ADDENDUM NO. 1

RFP EVMS GROSSLAB19-101

Gross Anatomy Lab Improvements at Lewis Hall

Date: May 07, 2019

DEMOLITION PLAN - SECOND FLOOR

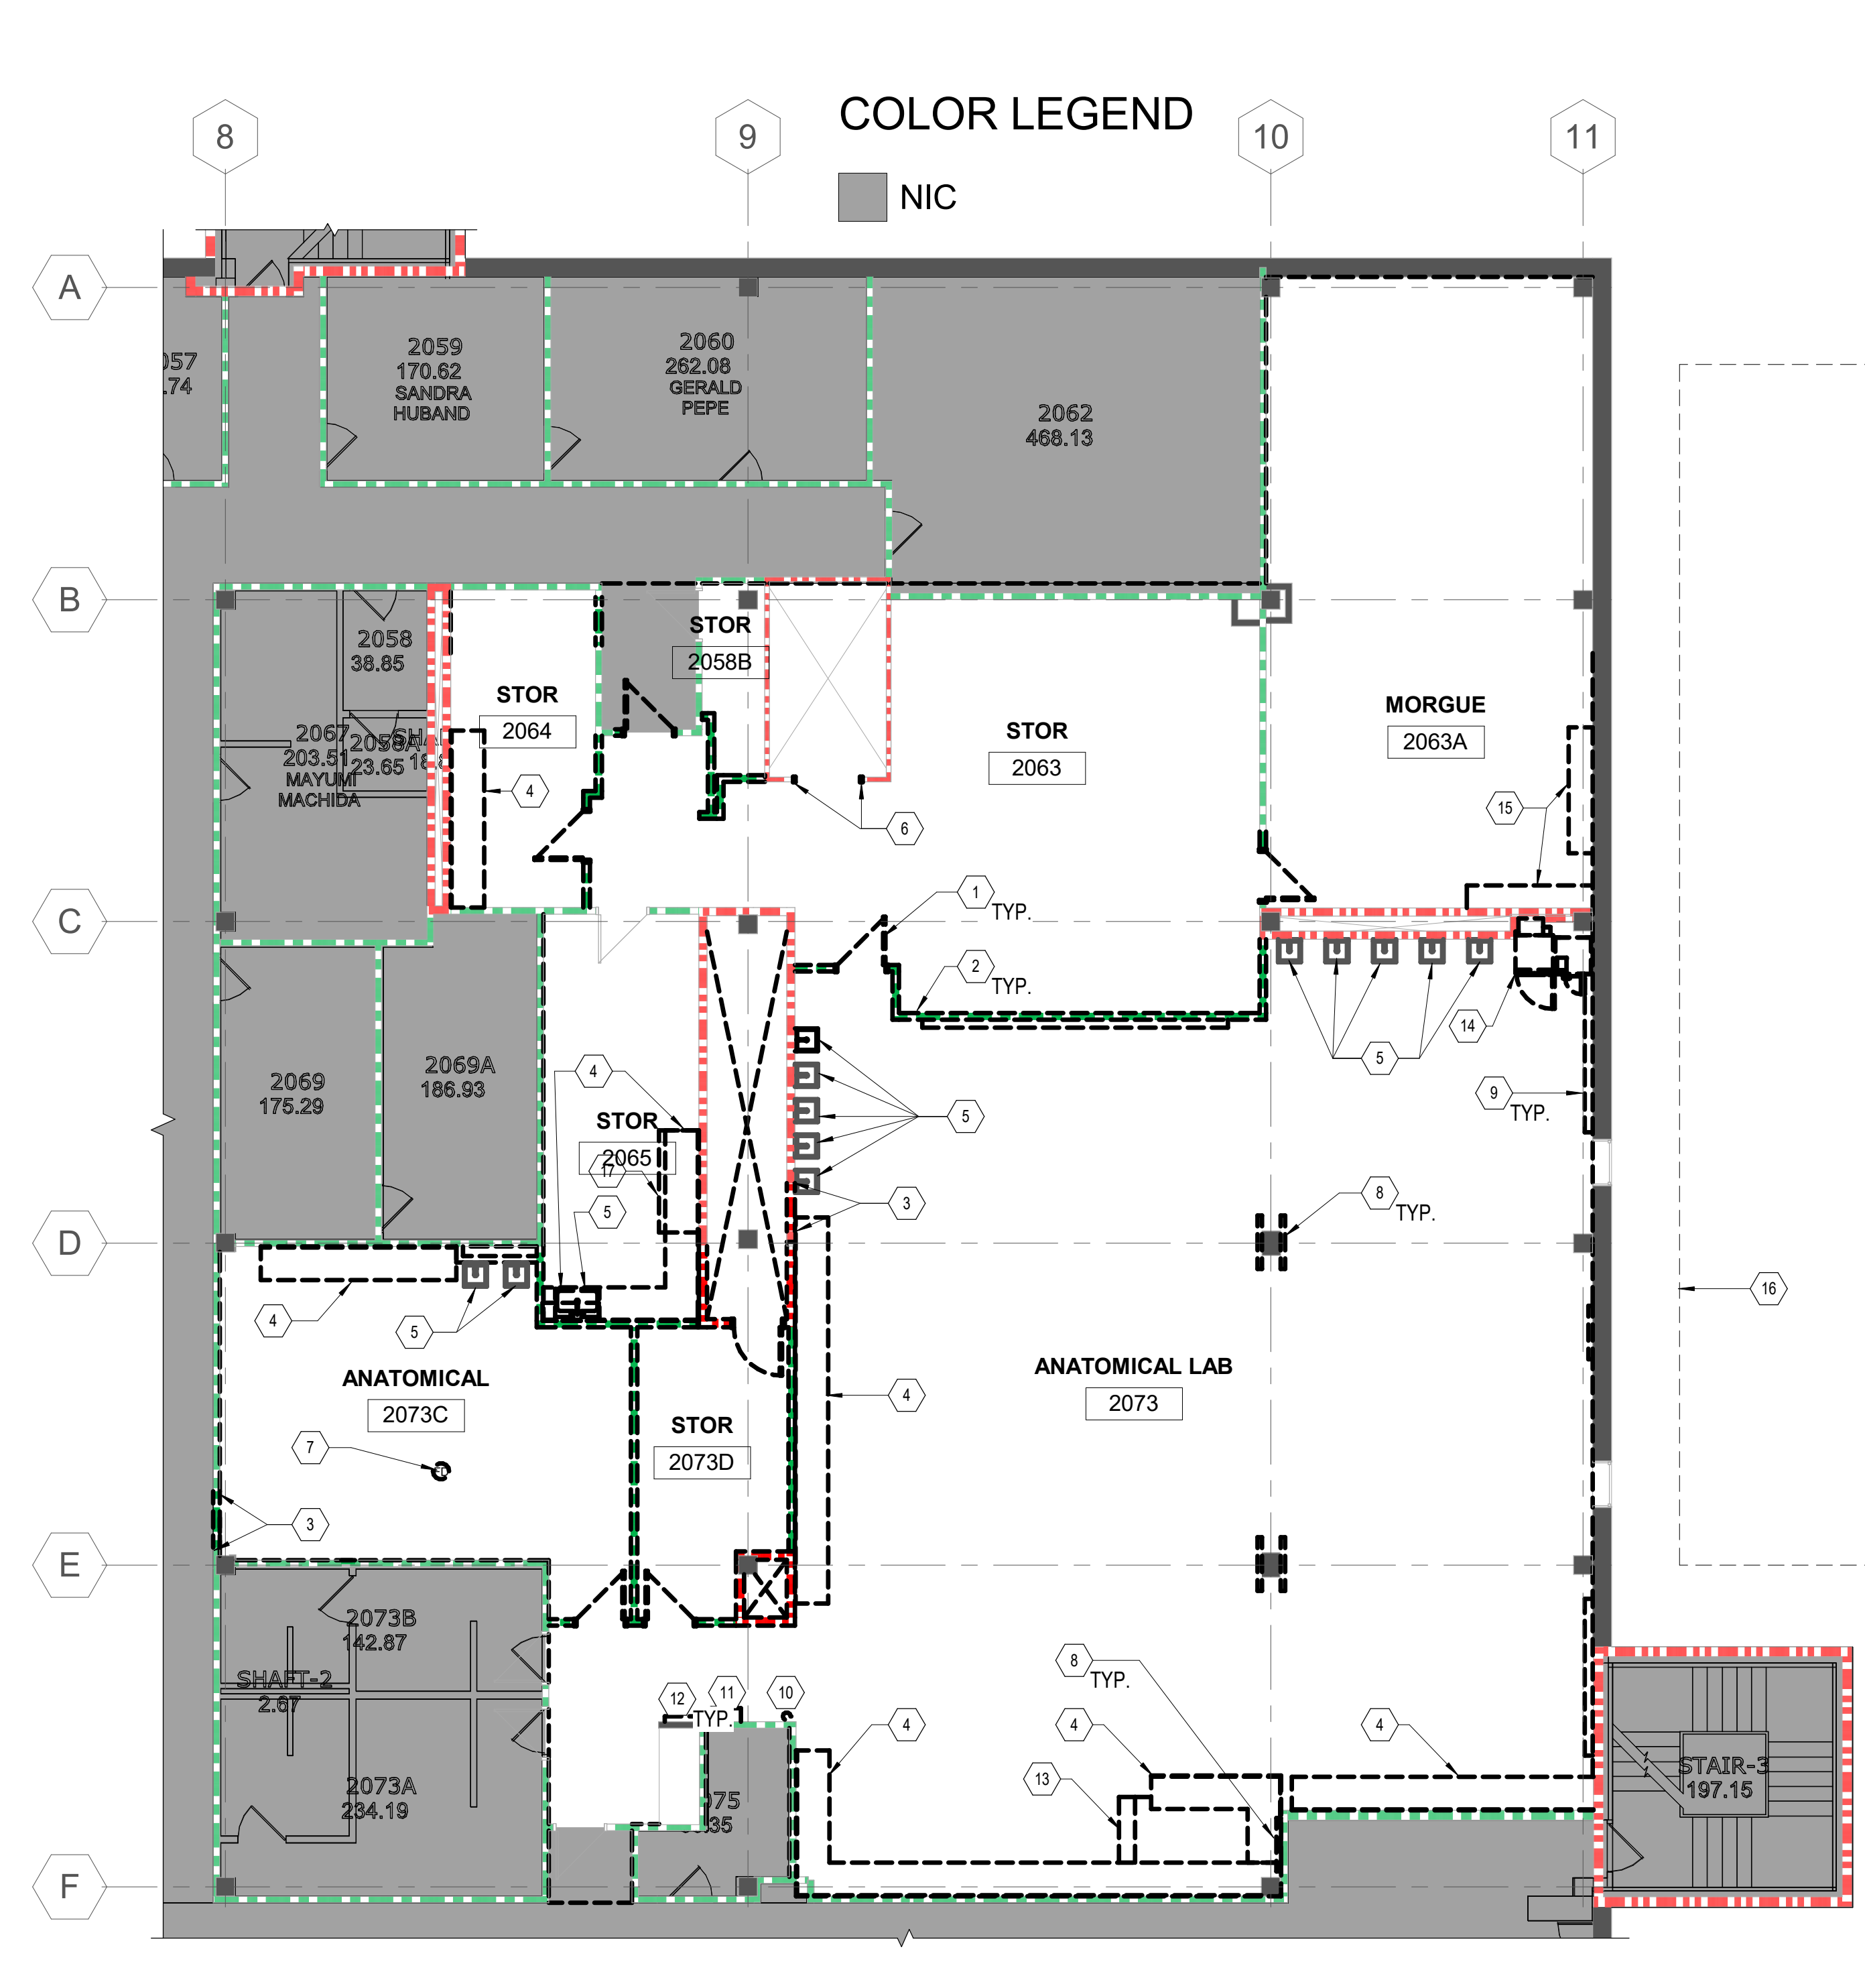
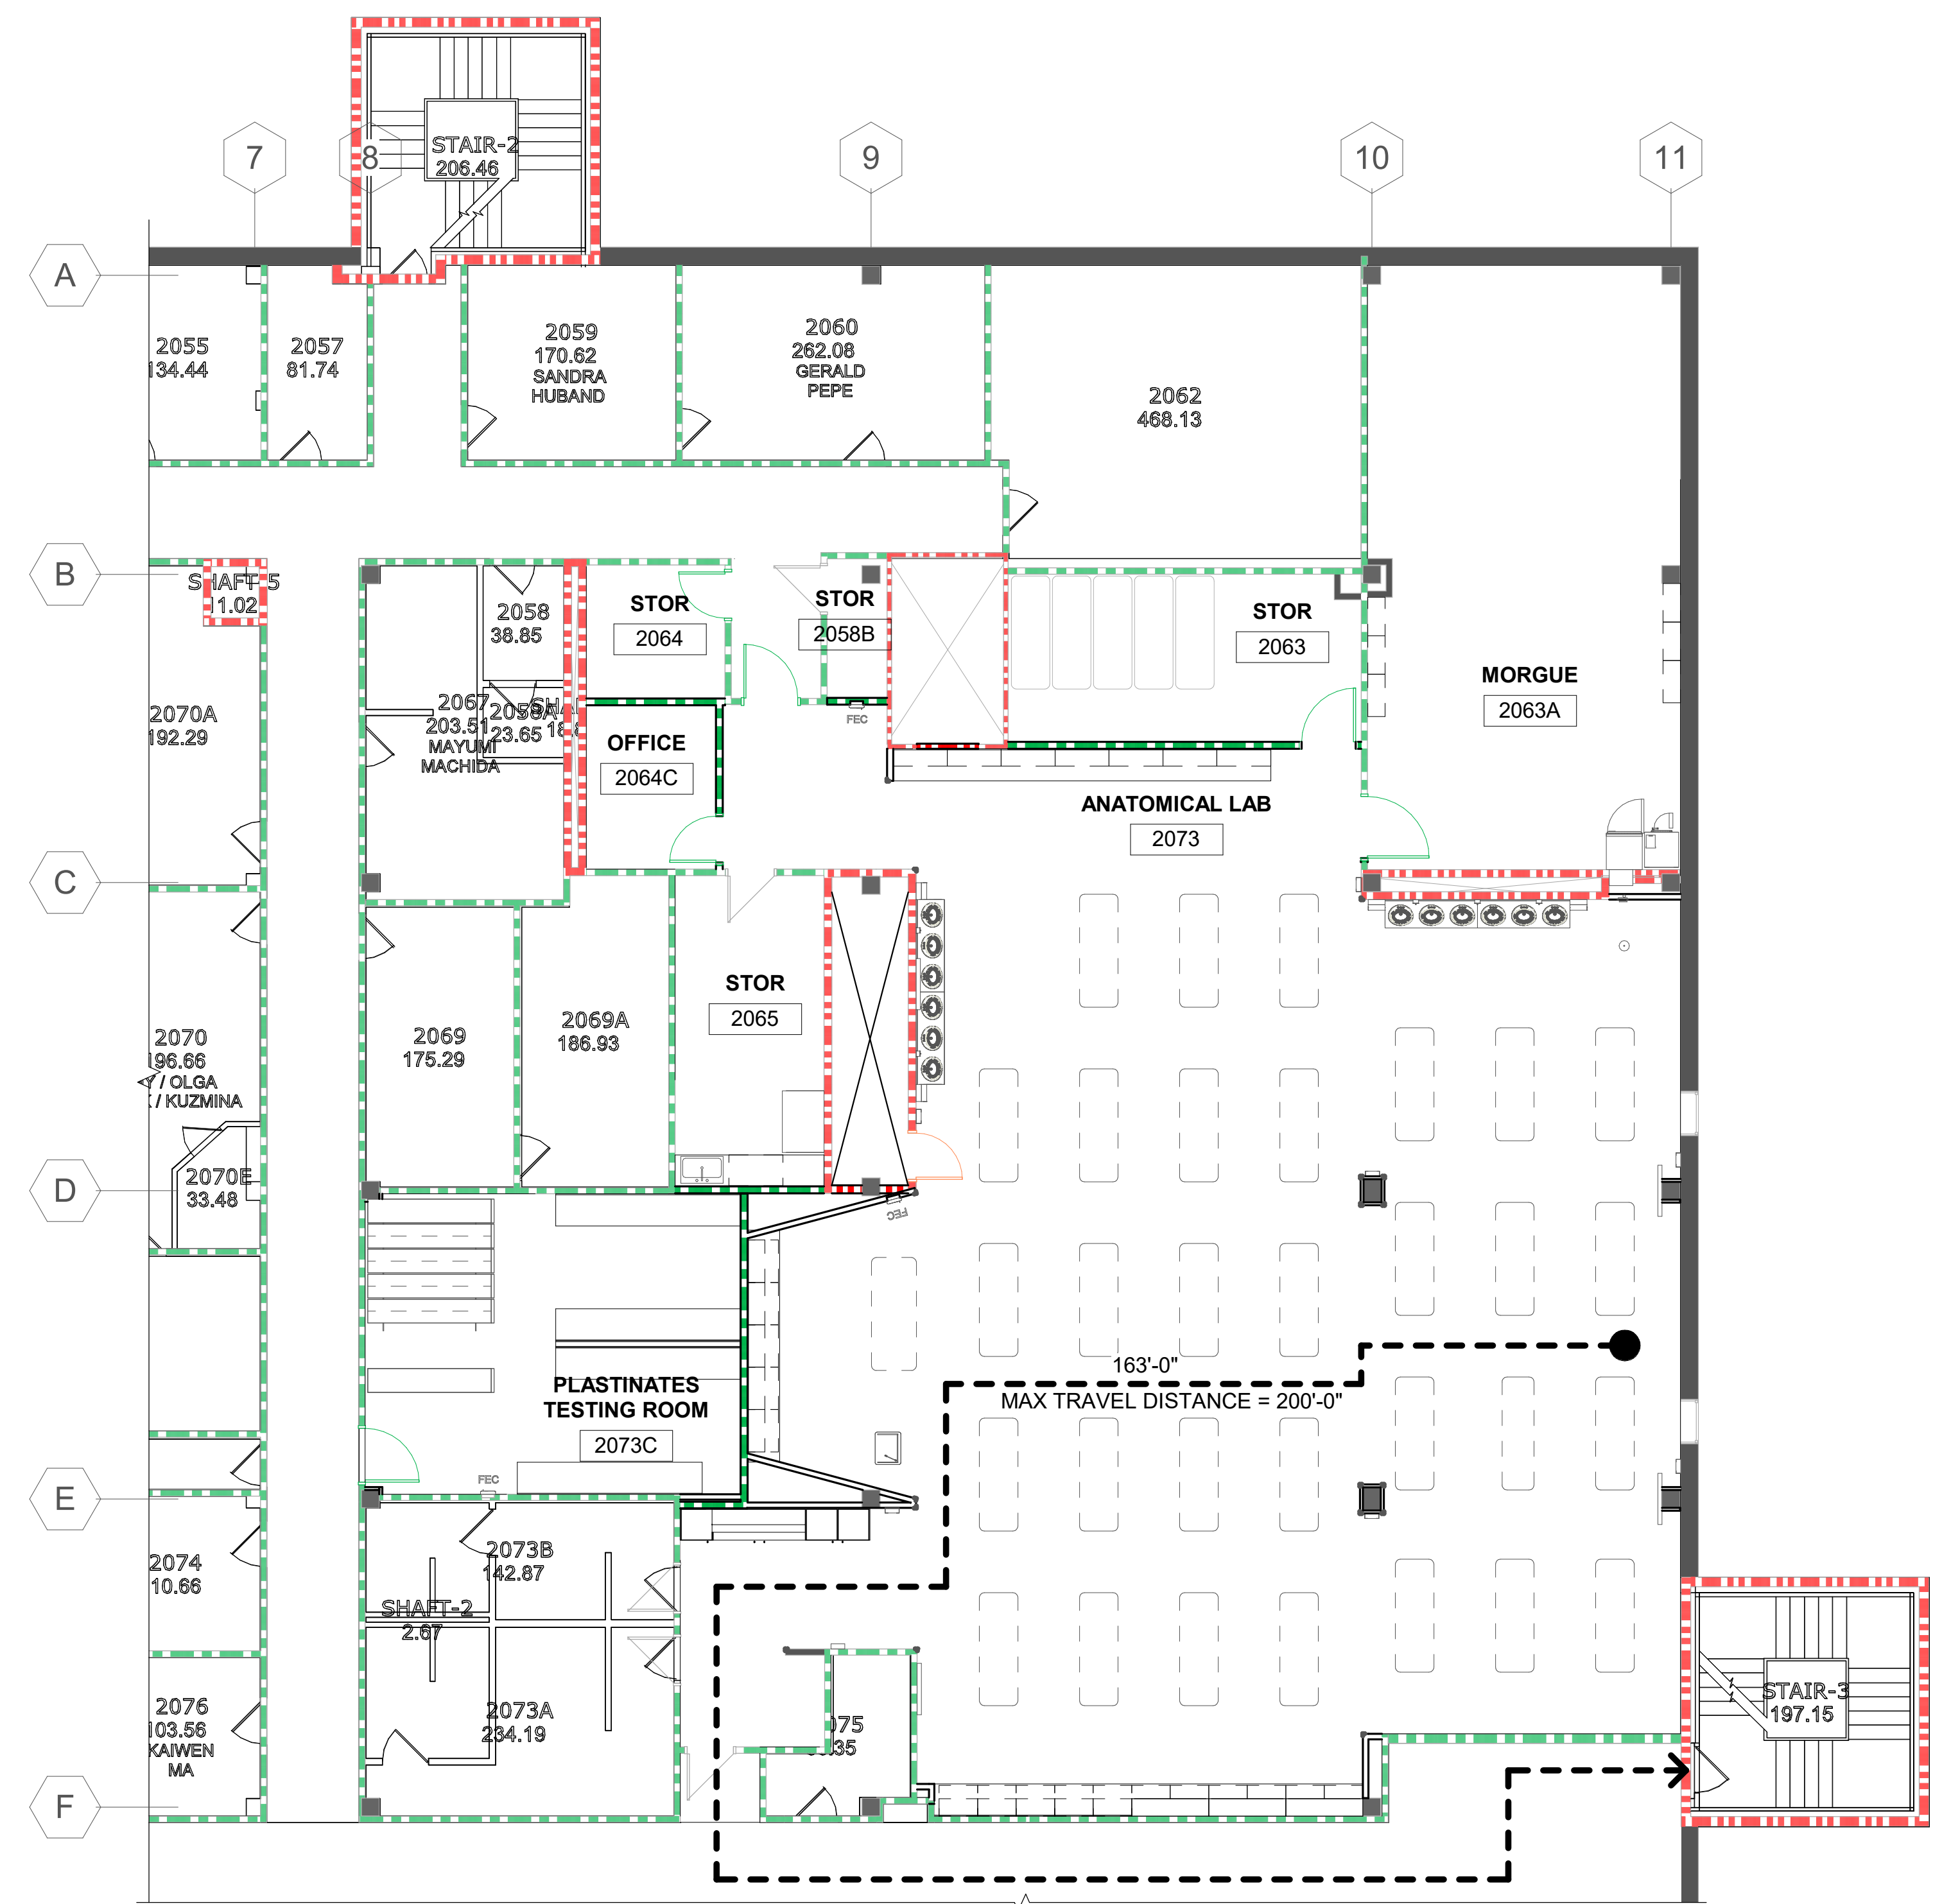
Drawing LS120, Demolition View - Auditorium Ceiling, add the following clarification: Ceiling removal will be required at areas where structural reinforcement is indicated. This includes the AHU-1 roof curb and the pipe support curbs. Note added to sheet LS120.

Drawing LS120, Demolition Schedule: The Demolition Schedule has been revised. See attached revised sheet LS120.

- ADDITIONAL STRUCTURE IS REQUIRED TO SUPPORT THE HVAC. REMOVAL OF PORTIONS OF THE AUDITORIUM CEILING IS REQUIRED TO INSTALL THE STRUCTURE. SEE PICTURES ON SHEET LS120 FOR MORE INFORMATION.
